Docket Item # 2
BAR CASE # 2008-0201

BAR Meeting
December 10, 2008

ISSUE: New mixed-use building
APPLICANT: Harrison Holdings LLC (John Marino)
LOCATION: 1123 Queen Street
ZONE: CL/Commercial Low

Figure 3: Front Elevation

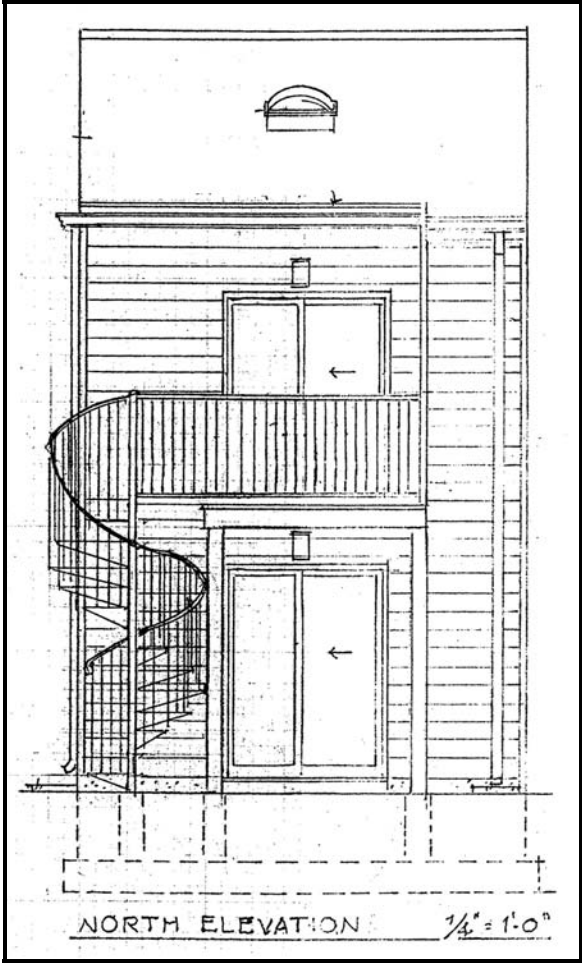
Front (south) Elevation – The front elevation of the building will be two bays wide with a front mansard roof and a sloping rubber membrane roof behind. The first floor will have a full light wood door with a two-light transom and a projecting bay window. The bay window will project almost 2' from the plane of the building and will have a wood cornice and two wood panels beneath. The glass on the front of the bay will be separated by a 1 1/8" wood muntin bar. The two Kolbe and Kolbe wood windows on the second floor will have a two-over-two light pattern, and will be double insulated with true divided lights and 1 1/8" muntins. This muntin width matches both the bay window and the historic windows on the adjacent house at 1119 ½ Queen Street. The building cornice will have dentils and three brackets, not unlike the Italianate house next door, and will be constructed of wood and Fypon. The house will be clad with smooth Hardi-plank siding in a Navajo beige color (the applicant has provided a color sample which will be available at the hearing). The standing seam metal mansard roof will be black and the trim throughout will be white. The front door will be stained. The house will sit on a concrete foundation and will have grass in the front, with the exception of the concrete walk leading to the building entrance. The trim on the front of the house will be wood, with the exception of the Fypon (a type of urethane millwork) used on the building cornice.

1. That the nails not show in the installation of the smooth Hardi-plank siding;
2. That a low or flat profile glass skylight be installed instead of the proposed acrylic dome skylight;

Figure 4: Rear Elevation

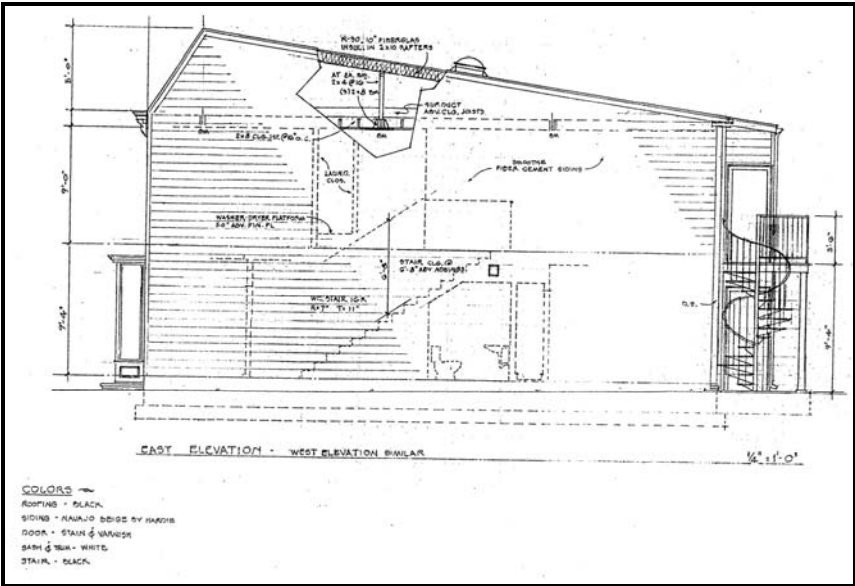
Rear (north) Elevation – The rear elevation will have full light sliding glass doors centered on each floor and a projecting two-story 3'6" by 3'6" mechanical enclosure. The second story deck will measure roughly 5' by 6' and will have a black metal railing and spiral stairs providing access to the ground floor. The deck will be constructed of Trex, a composite material of wood and vinyl and the gutters and downspouts will be aluminum. A domed skylight will be installed on the rear slope of the rubber roof. The applicant does not intend to install a fence to enclose the rear yard. The rear elevation will be minimally, if at all, visible from the alley in the center of the block.

While the Boards generally discourage the use of spiral stairs, the *Design Guidelines* state that they are "...appropriate for late-20th century buildings and should be inconspicuously located." Staff has no objection to the stair because it will not be visible from the rear and only a small portion – 1 foot – projects beyond the building wall and will be visible from Queen Street. To comply with the *Guidelines* as they relate to skylights, Staff recommends that a low or flat profile glass skylight be used instead of the proposed acrylic dome skylight.

Figure 5: Side Elevation

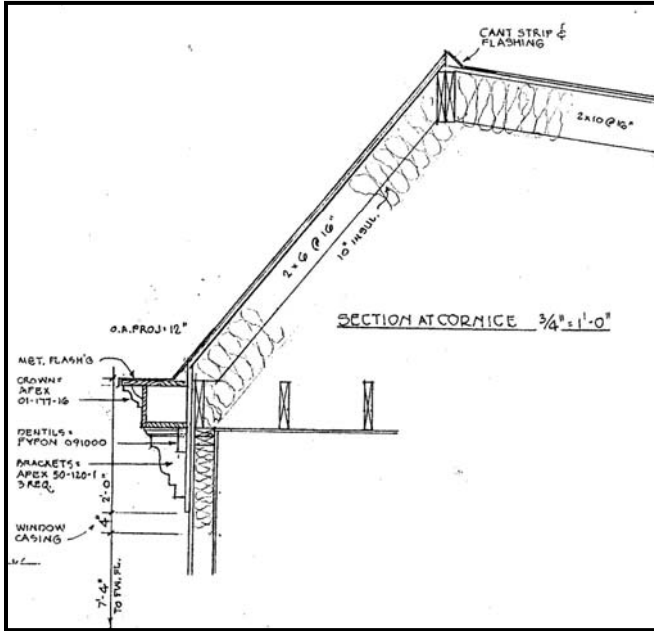
Side (east and west) Elevations – Neither the east or west elevation will have any penetrations. The side elevations will be minimally visible between the 2' and 3' gaps separating the subject property from the adjacent buildings. Two electric meters will be installed on the east elevation where they will be minimally visible.

- C-1 All exterior walls within 5 feet from an interior property line shall have a fire resistance rating of 1 hour, from both sides of the wall. As alternative, a 2 hour fire wall may be provided. This condition is also applicable to skylights within setback distance. Openings in exterior walls between 3 and 5 feet shall not exceed 25% of the area of the entire wall surface (This shall include bay windows). Openings shall not be permitted in exterior walls within 3 feet of an interior lot line.

Figure 6: Cornice Detail

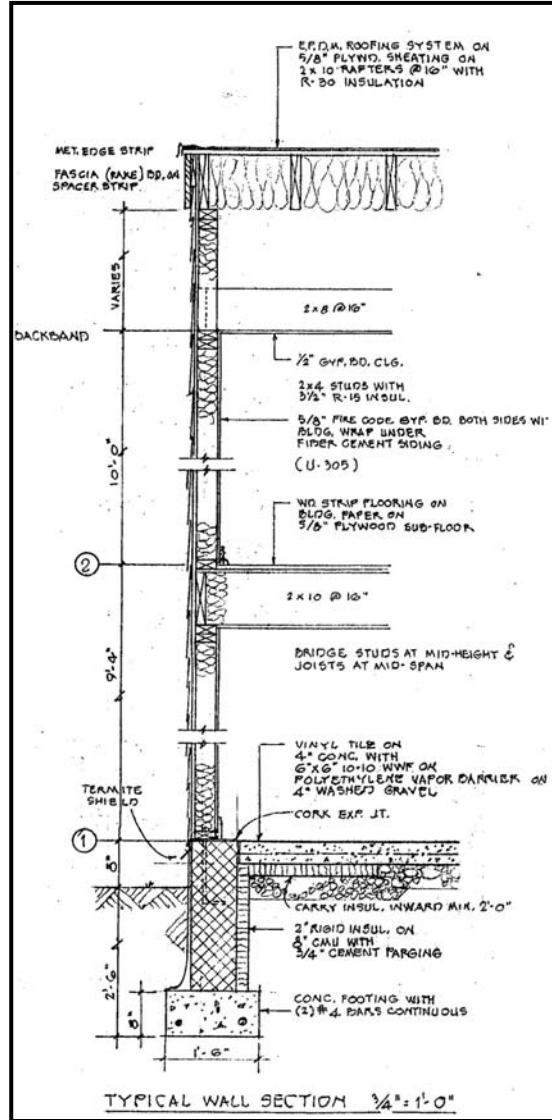
Thus, the use of fiber cement on this new building is in conformance with the Board's policy, provided that the smooth fiber cement siding be installed so that the nails do not show. Staff also has no objection to the use of Fypon on the upper cornice because it will be located 19' above street level. The Trex material proposed for the rear deck will not be visible from a public right-of-way.
